TENNESSEE D.O.T.
DESIGN DIVISION
FILE NO.

TYPE	YEAR	PROJECT NO.	SHEET NO.
RESURF.	2014	HSIP-431(14)	3

TYPICAL SECTIONS
(NOT TO SCALE)

ALTERNATE AA1

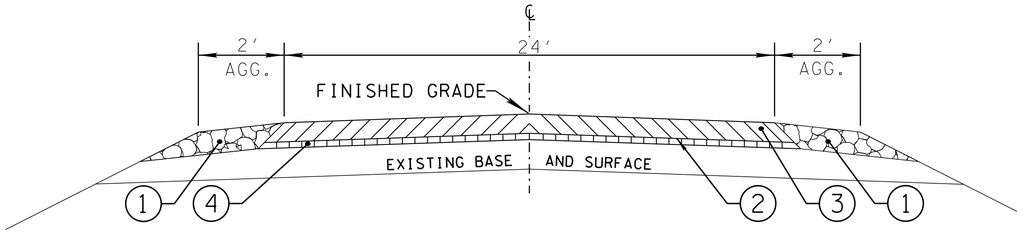
REV. 03-07-14: ADDED TYPICAL & PROPOSED PAVEMENT SCHEDULE FOR ALTERNATE AA2. REMOVED TACK COAT LAYER BELOW BSC LAYER ON ALTERNATE AA1.
